KENNEBUNKPORT ZONING BOARD OF APPEALS
Administrative Appeal Application

Addendum to Appeal to ZBA

This Appeal is filed on behalf of Randy Slager. The decision appealed from is the CEO's December 3, 2019 action lifting the prior CEO's July 17, 2019 suspension order on Ms. Bell's building permit #18-418, and land use permit #18-419, as shown in his e-mail to Lori Bell (copy attached as Exhibit 'A'.)

Subject: Response to Price Structural Engineers February 19, 2020 letter regarding
Rubble Retaining Walls and Stone Veneer/Reinforced Masonry Retaining Walls
200 Ocean Avenue, Kennebunkport, ME

2. Selected Excerpts from JTTLA – “Permit Drawings” (specified construction documents)

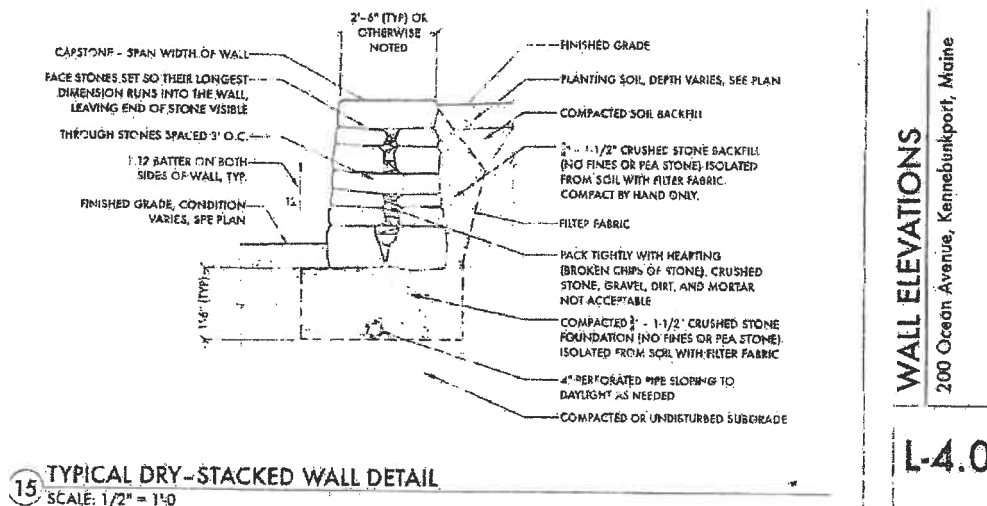
New exterior walls were specified to be constructed in accordance with the “Typical Dry-Stacked Wall Detail” at Detail number 15 on Drawing L-4.0 (below).

- “Capstone – Span width of wall”, typical full length of wall
- “Face stones set so their longest dimension runs into the wall, leaving end of stone visible”
- “Through stones* spaced at 3’0” on center”
- “1:12 batter on both sides of wall, typ.”, slope at each side for added stability
- “¾” – 1 ½” crushed stone backfill (no fines or pea stone)”
- “¾” – 1 ½” crushed stone foundation (no fines or pea stone)”

* “Through stones”, as depicted on Detail 15 / L-4.0, are stones extending the full width of the wall with each end of the stone extending to the outside face of the wall. “Through stones” are the same as “capstones” except that the through-stones are located at the mid-height of the wall instead of at the top.

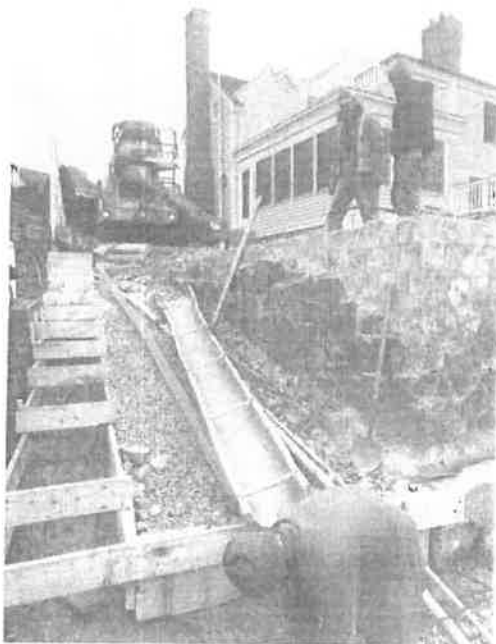
Photo #11 (by others) – View looking north. Photo and caption above from Joshua Tomkins on 1/15/19 at Wall A-11. Soil added up to bottom of forms. No ledge is observed or referenced in the caption. No soil compactors observed in photo. Plastic sheeting or filter fabric added. No ledge observed for securing steel pins into ledge under footing as reported. Note generator at upper left of photo.

Photo #12 (by others) – Similar view as Photo #11 above, it is not clear what material the pins are embedded into. Based on Photos #9, #10, and #11, it appears doubtful that the material directly below the footing is ledge. Note location of blue underdrain is the same in both photos.

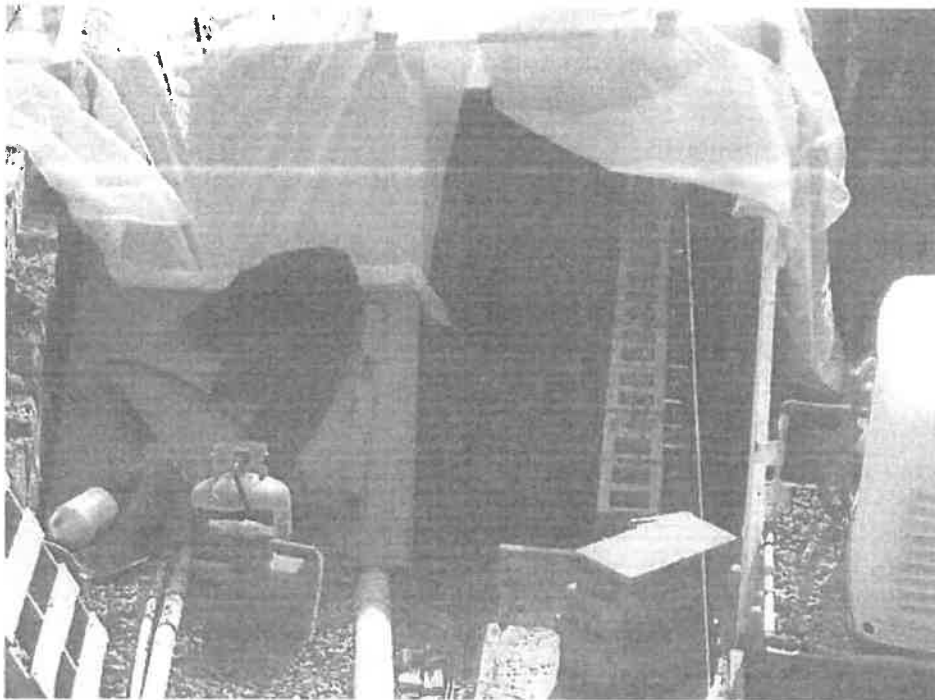
Photo #14 (by others) – View looking south. Concrete masonry block appears to have metal tie connectors at right side. Metal tie connectors are often used to connect stone veneer to CMU walls. Also note there appears to be vertical steel reinforcement inside the CMU vertical cells. Most of the bars are near the center of the core, but some are toward the west side of the cell (which reduces strength).

SK-2

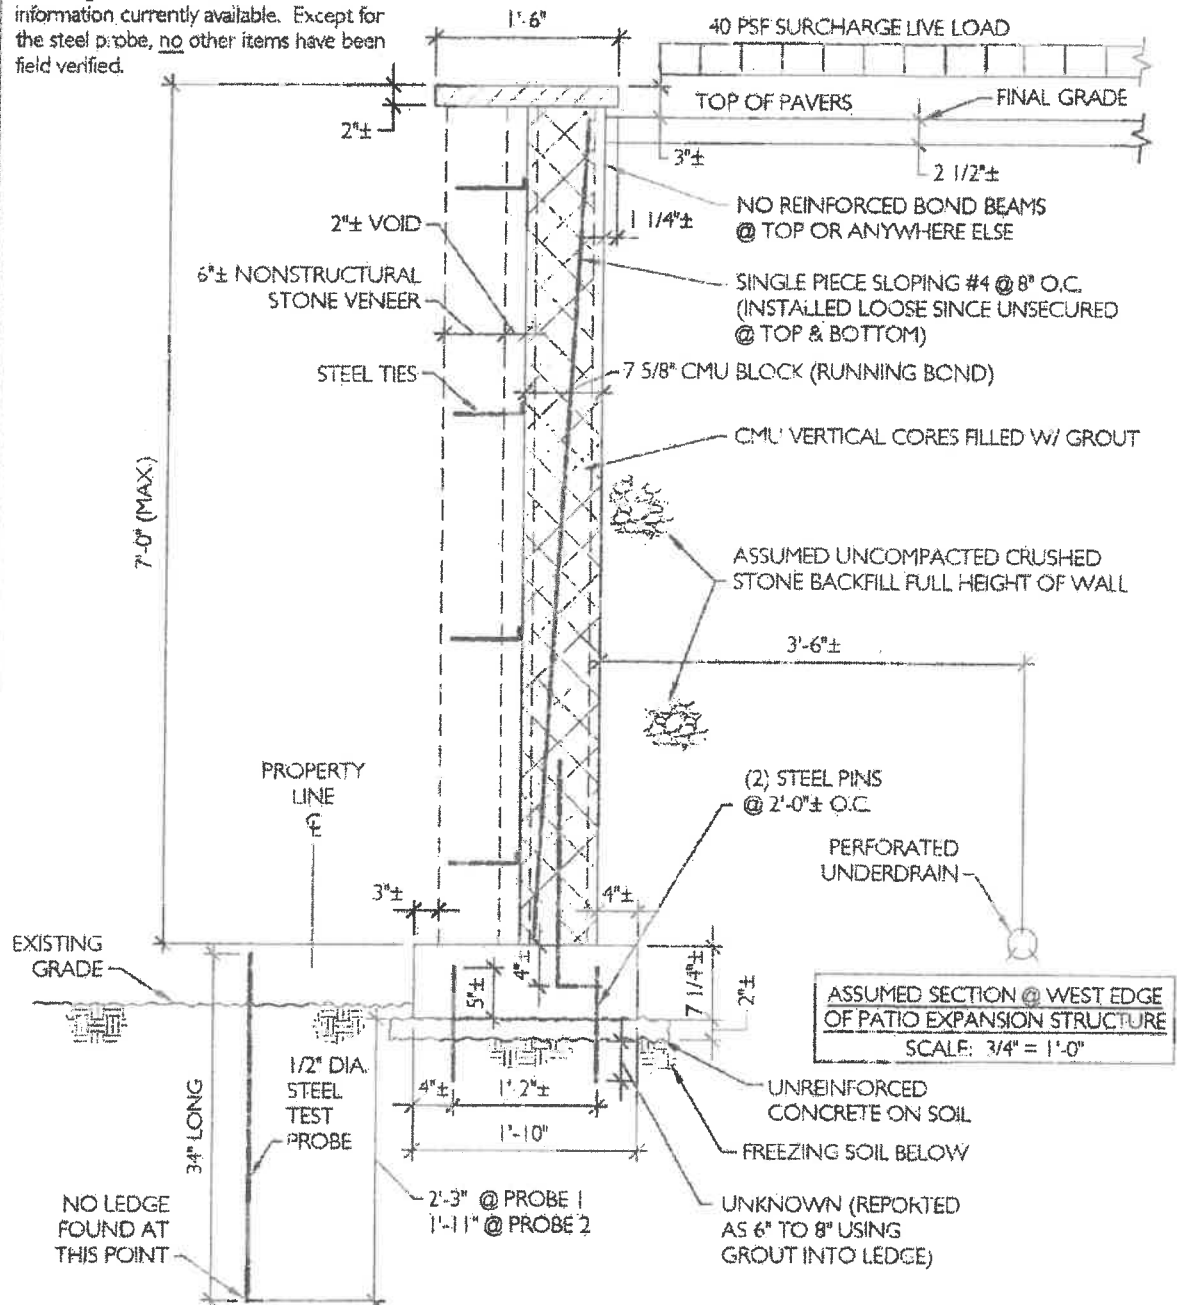
- b. Based on the information below, see the attached Detail SK-2 (page 21) for PSE's current understanding of how wall A-11 was constructed.

NOTE: This section indicates the assumed "As-Built" construction of the west edge of the structure based on information currently available. Except for the steel probe, no other items have been field verified.

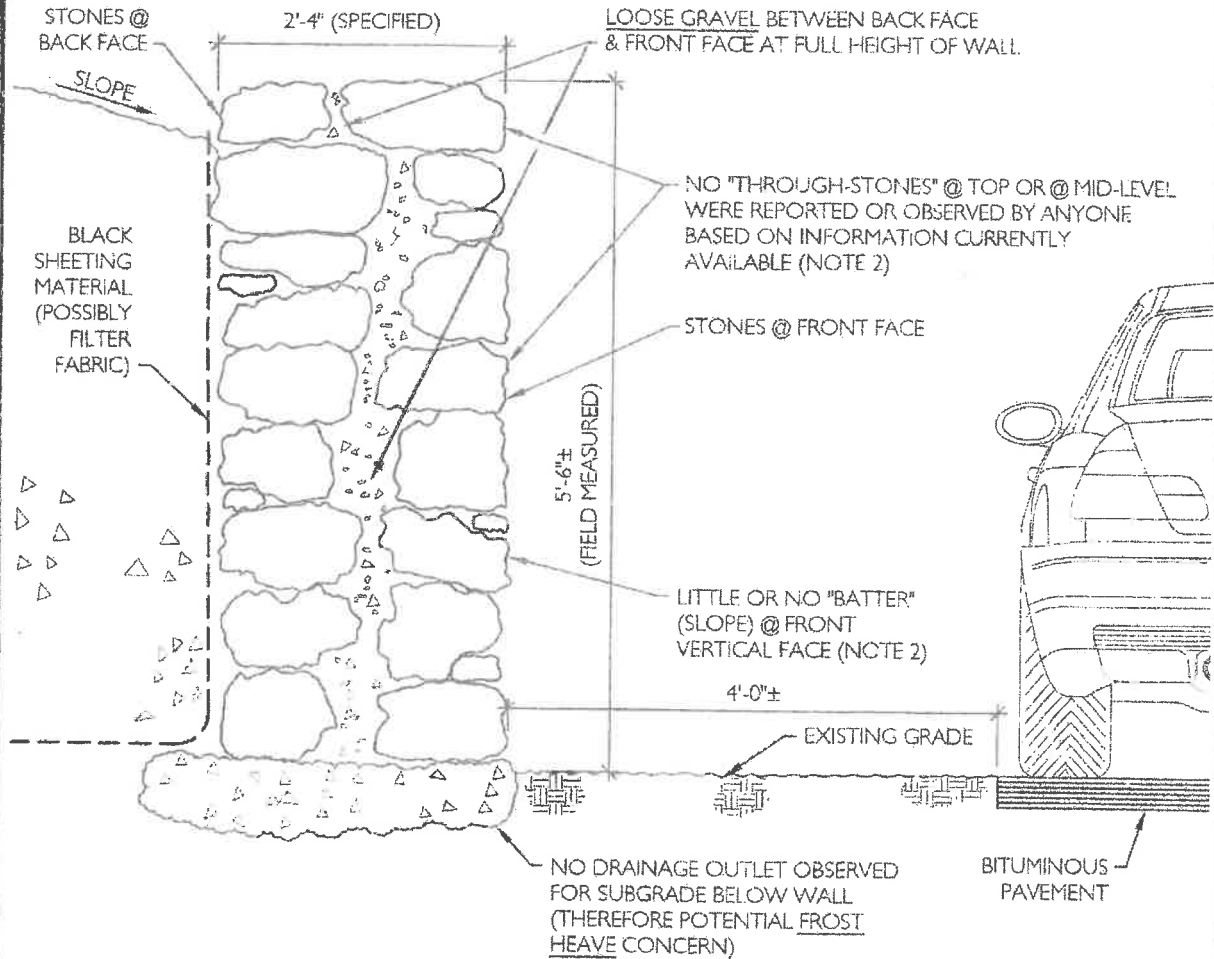
- a. Based on the information below, see the attached Detail SK-3 (page 22) for PSE's current understanding of how wall A-11 was constructed.

- NOTES:**
1. Based on the documents, field measurements, observations, reported information and photographs currently available, this sketch represents what is believed to be the as-built condition of the stone rubble retaining walls labeled "A1" and "A2" adjacent to Shore Road. The concern is that because there are no bondar units ("through-stones") at the top or mid-level, the stones at the front face are acting alone as a wall resisting large lateral loads and frost heave. This is because the stones at the back face provide no lateral support assistance to the stones at the front face.
 2. Lack of through-stones and missing battered front slope were reported in the 4/3/19 report by Structural Integrity Consulting Engineers, Inc.

Kennebunkport
Sheet: 9 of
Job #: 132-19
Checked by:

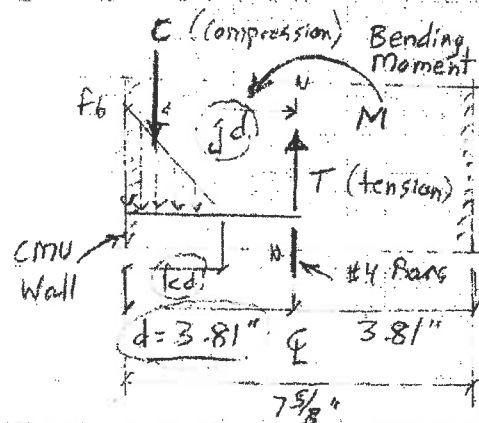
$$F_b = \frac{2 (M)}{b (k d) (j d)} = \frac{2 (1957 \text{ ft-lb} (12))}{(12") (1.556") (3.29)} = 765 \text{ psi} > 675 \text{ psi}$$

$$\text{Overstress} = \left[\frac{765 - 675}{675} \right] 100\% = 13\% \text{ overstress} \quad \text{EXCESSIVE CODE VIOLATION}$$

Kennebunkport
Sheet: 4 of
Job #: 132-19
Checked by:

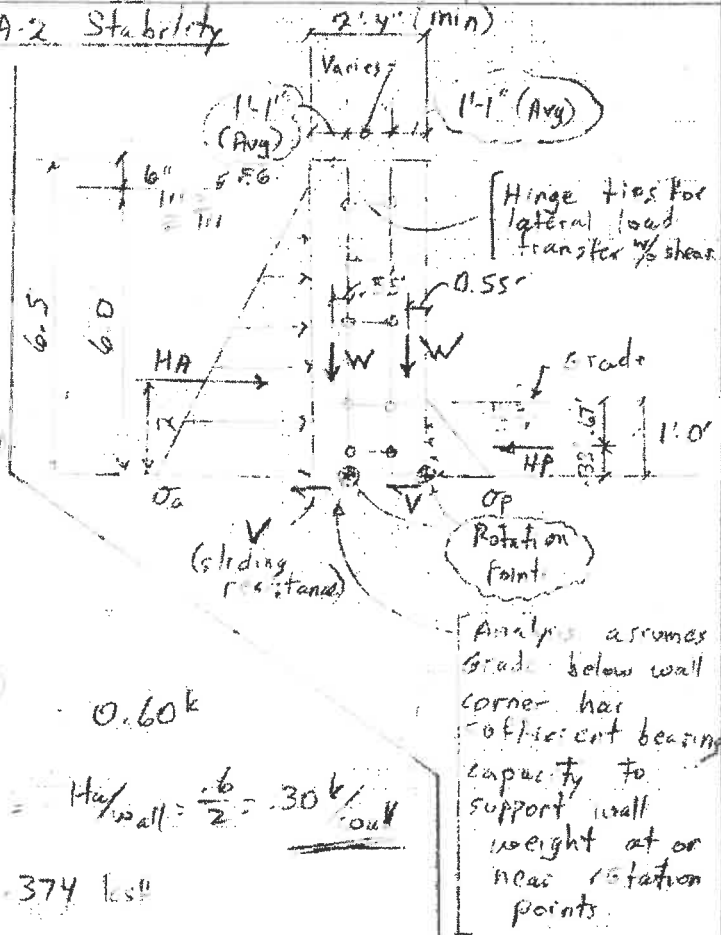
$$SF = \frac{M_R}{M_o} = \frac{0.50}{.72} = 0.70 < 1.5$$

Extreme instability
w/ regard to overturning

PHOTO 1 - PROGRESS OF WALL A11

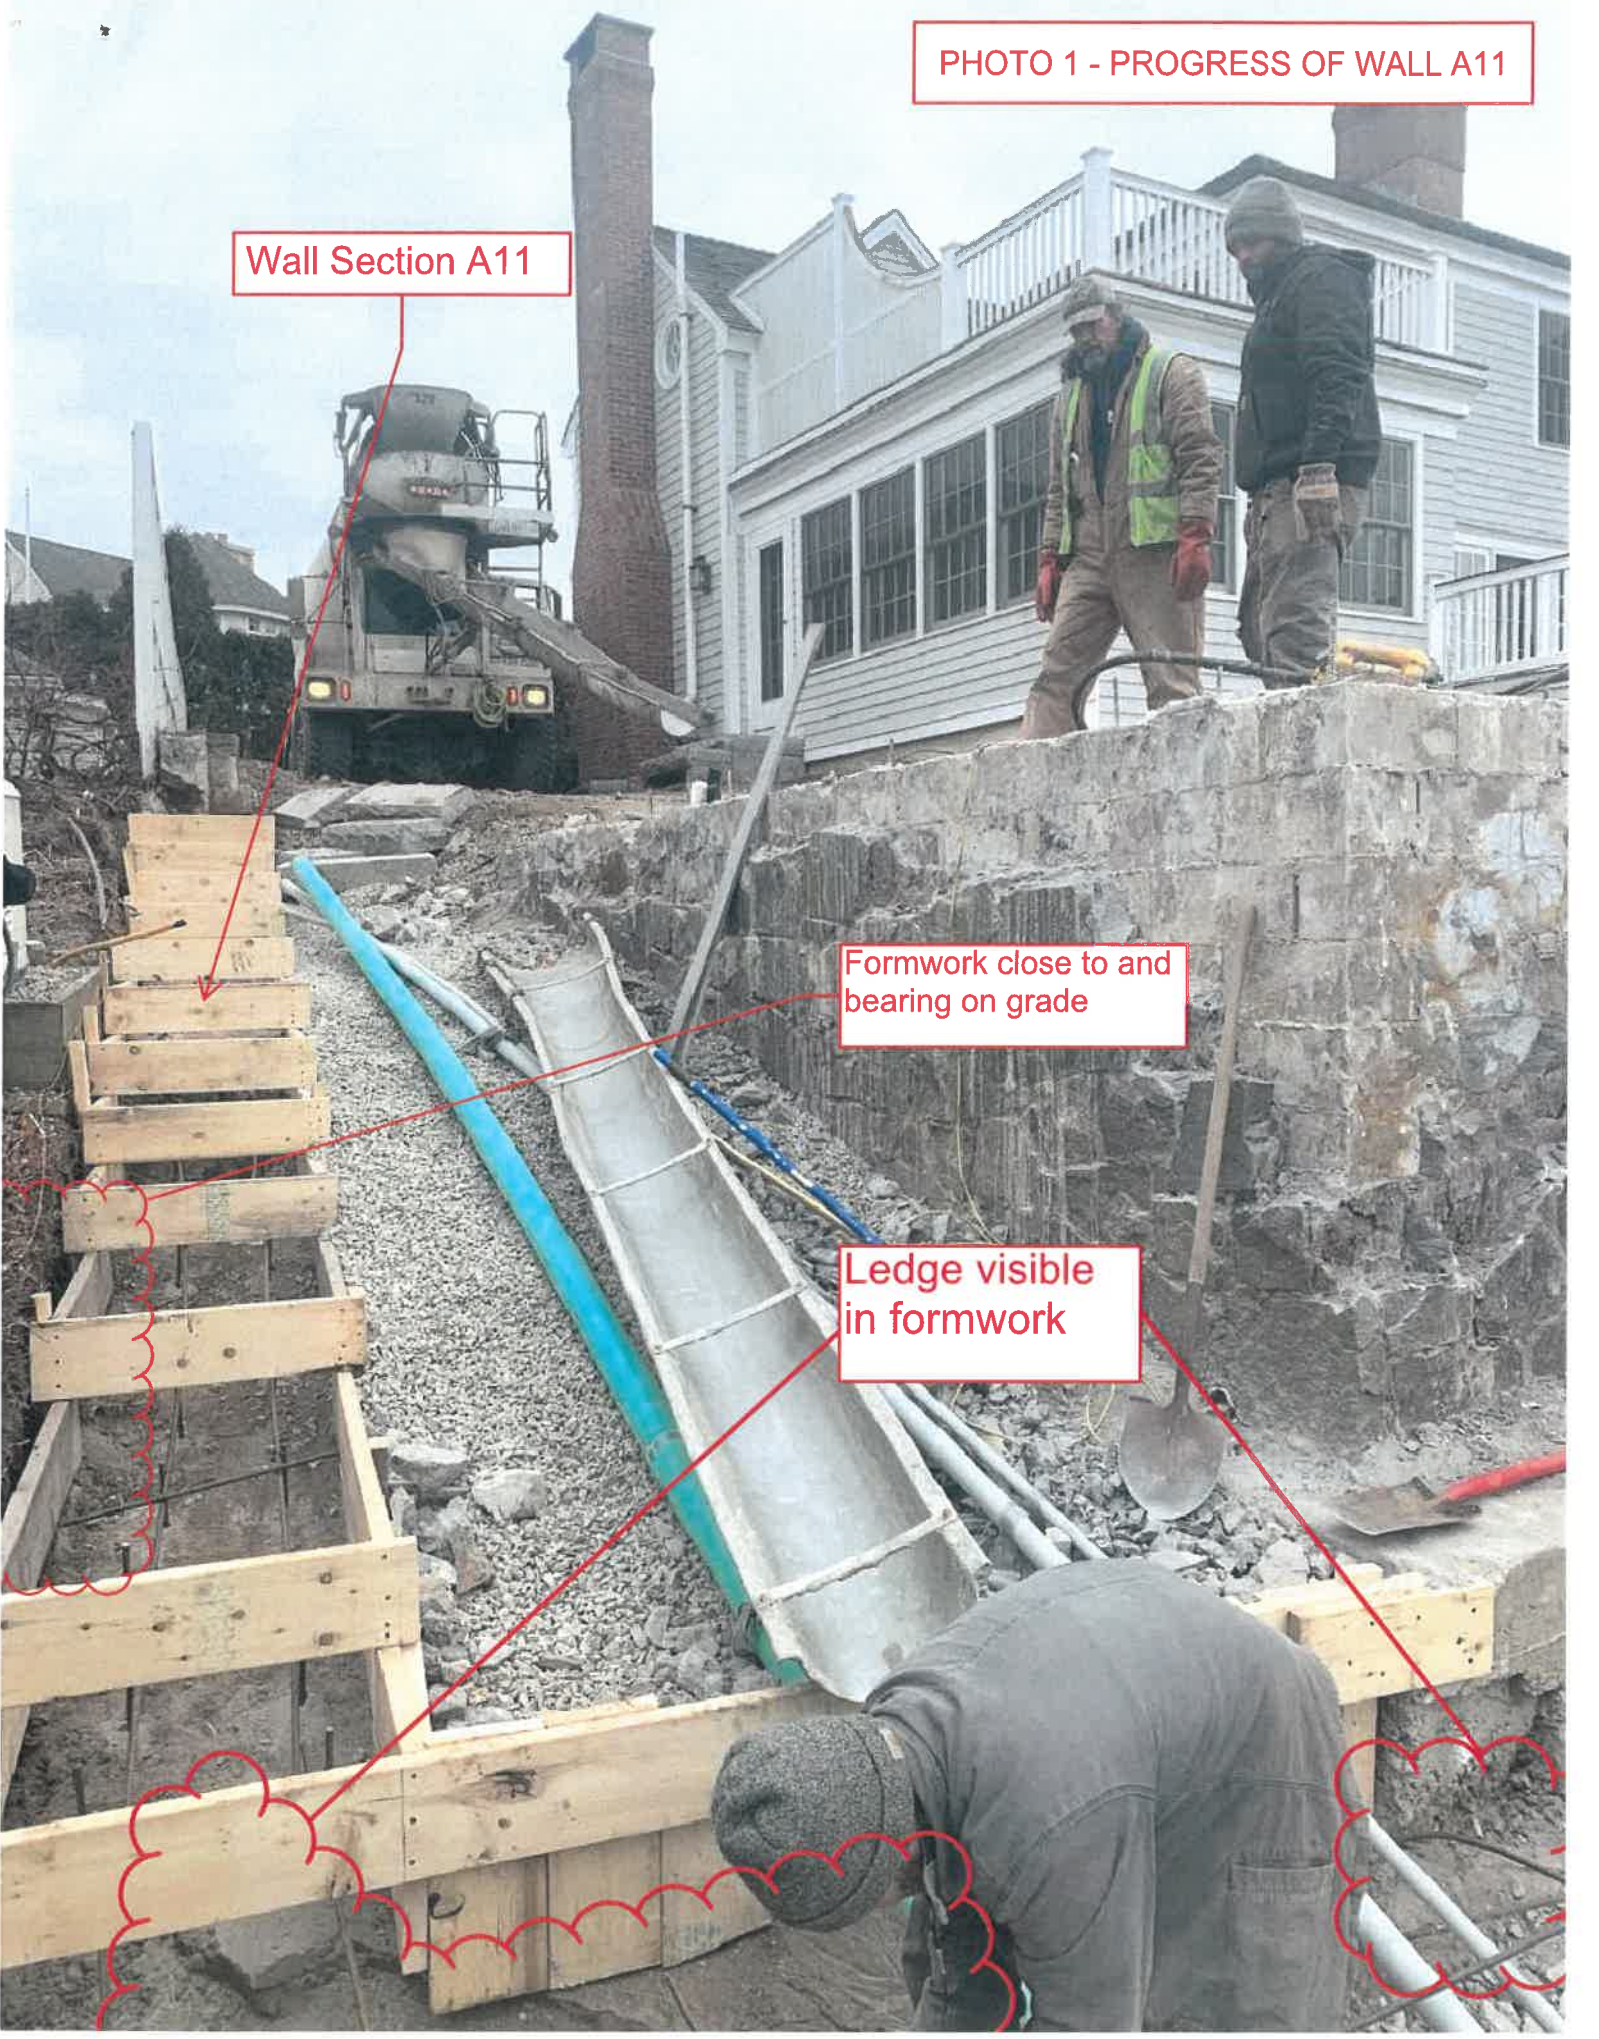
Again, PSE misconstrues information to support mistaken claims. The photo on page 8 of PSE's 2/19/20 report is the basis for "convincing and irrefutable evidence" that the CMU wall's footing does not bear on ledge. The Page 8 photo is taken too far away to make any conclusions whatsoever regarding the material footings bear on. The Photo cannot be reliably used to either support or refute what the footings bear on. Other photos (including one used in an earlier PSE letter) taken more closely to the wall clearly show that ledge is present in formwork. Please see Photo 1 at the end of this letter. Photo 1 further shows that

When additional information is gathered, PSE seeks to discredit facts which they do not suit PSE’s conclusions. Three test holes were dug on 2/5/2020 and found ledge below the CMU wall footing, as documented in our 2/5/2020 letter. Despite the new test holes, past photos, testimony by the builder, knowledge of the site from former and current owners, somehow PSE is alone in the belief that the wall does not bear on ledge. PSE tries to discredit plausible explanations regarding the findings of their probes, saying on page 9, “The Bell team is proposing that all of the A11 footings are bearing on ledge and that the edge of the ledge, perhaps somehow by amazing good luck and coincidence, just happens to align perfectly with the existing property line. On its face, this does appear to be suspiciously very convenient. The Bell team is further stating that they have no problem believing that the ledge is essentially at the top of the existing grade or close to it all along the property line but that just 17” to the west the ledge immediately drops off to more than 27” below top of grade.” Perhaps PSE is unaware that owners regularly adjust the elevation of ledge on their property, while not touching the rock on adjacent properties. Ledge removal is expensive, so owners remove as little ledge as possible to suit their goals. PSE may also be unaware that elevation of ledge can rapidly naturally change in Maine. Both common facts easily explain how ledge can vary over a short distance. Please also note – depth to ledge was about 8 to 10 inches below the grade at one of the test holes we dug, and 12 to 14 inches at another. Ledge would have to drop only 17 to 10 inches away from the wall to be lower than PSE’s probes. Wall A11 is founded on ledge, and so is not susceptible to frost heaves.
